Report of the CAA's Post Implementation Review of the implementation of RNAV-1 Standard Instrument Departures at Gatwick Airport

Annex 6: CAA IFP Recommendations report

Annex 6 to CAP 1346

Route 3 Gate layout

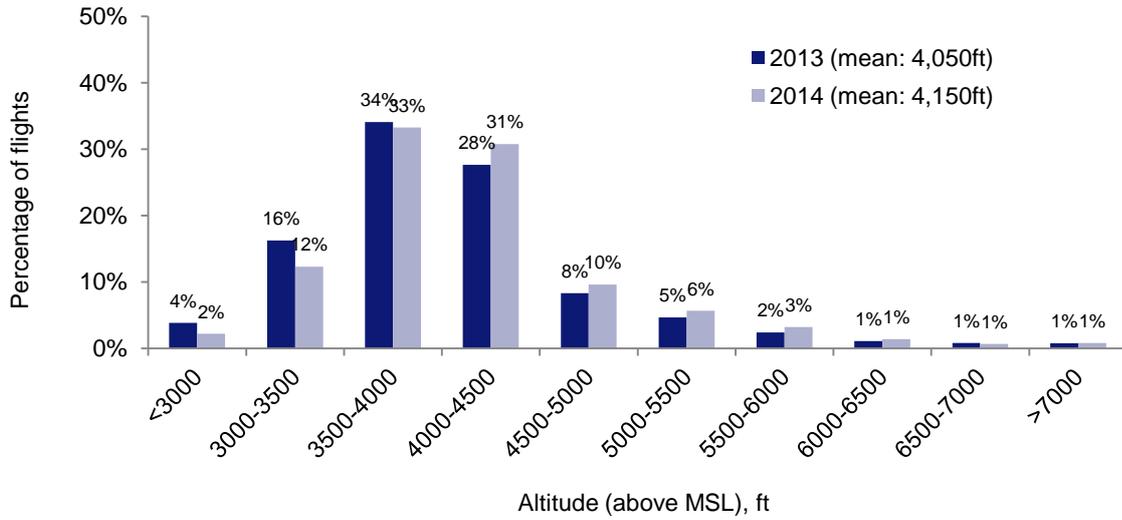
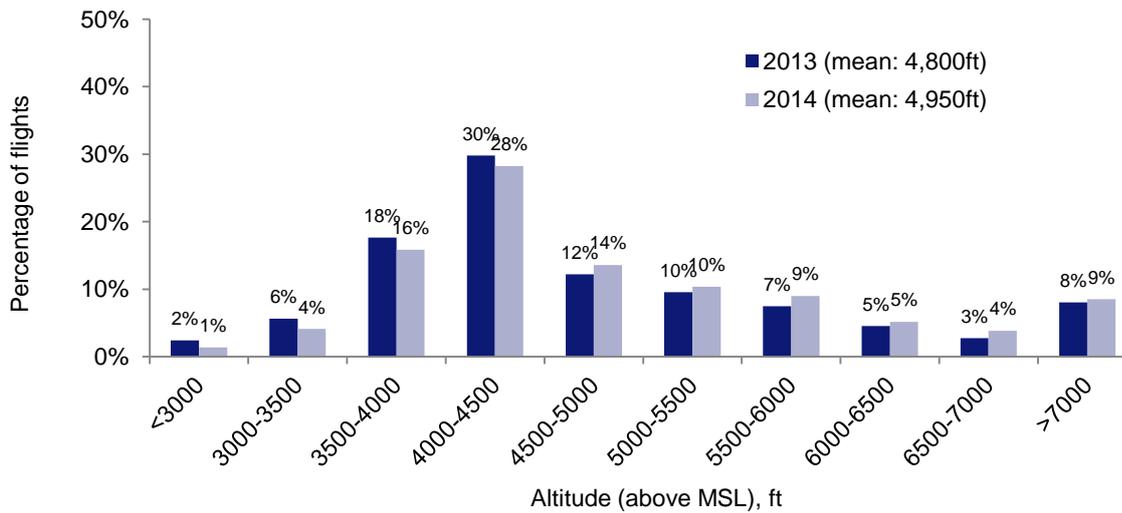
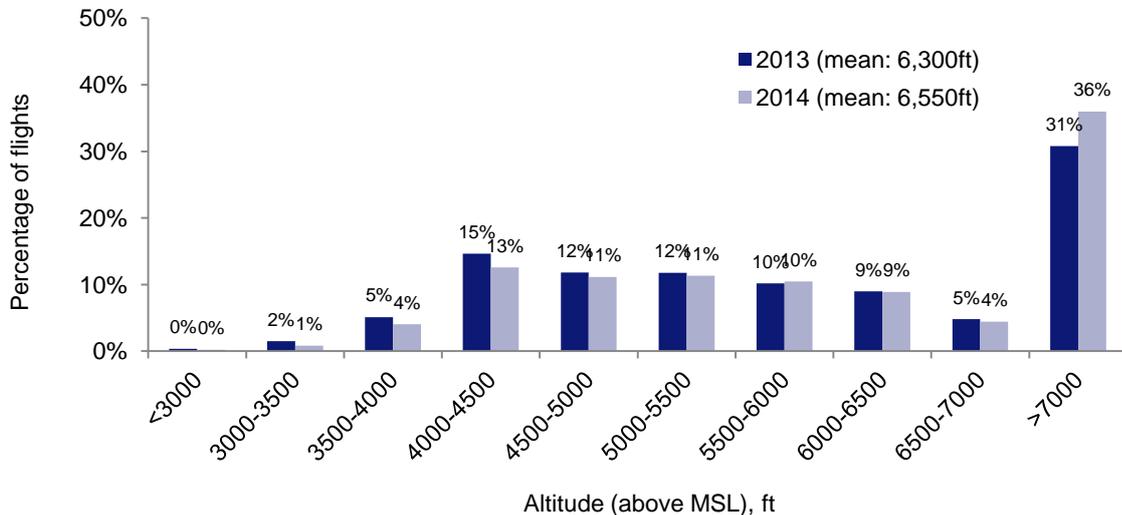
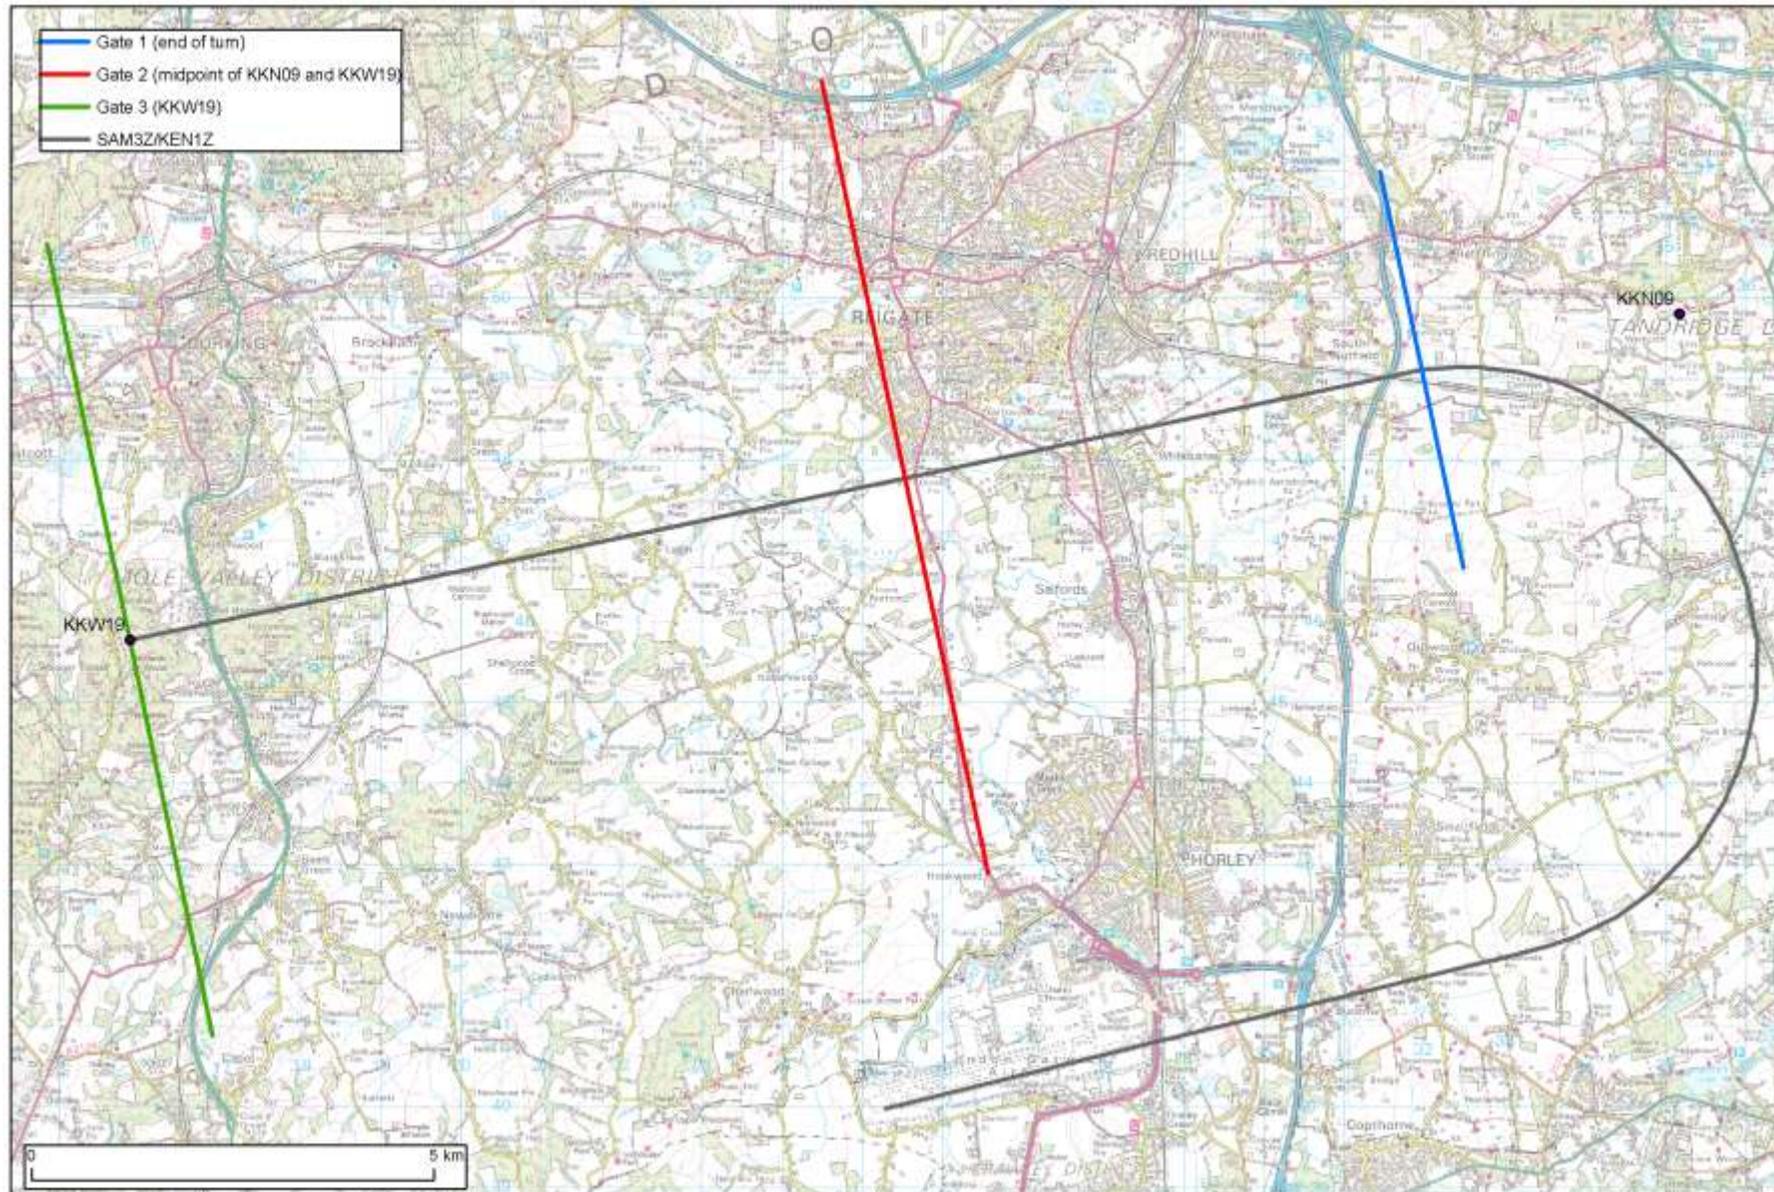
(1) Route No.	(2) SID/Data used during analysis	(3) Issue	(4) Initial Options from SARG IFP For PIRG to Consider	(5) Impact of Issue & Initial Options	(6) Outcome of PIRG Final Review of Route Issues & SARG IFP Options	(7) SARG IFP Recommendations
3 (cont)		<p>restriction at KKW19 is due to interaction with Heathrow Rwy 09 MID SIDs, initial re-examination of the altitude attainment diagrams (see below) indicates a/c are climbed above 4000ft significantly earlier on the SID profile</p> <p>The documented level restriction rationale of the RNAV 1 SID is as follows:</p> <ul style="list-style-type: none"> • KKE05 +2500: Noise Abatement • KKN09 @3000: Noise Abatement • KKW19 @3000: Airspace Containment and Separation against EGLL DVR SID • KKW26 @4000: Airspace Containment and Separation against EGLL MID SID 		<p>the analysis), average alt 4950ft amsl, and 95% were at/above 4000ft amsl by KKW19 with an average altitude of 6550ft AMSL.</p> <p>Therefore in reality altitude attainment of above 3000ft is not an issue.</p>
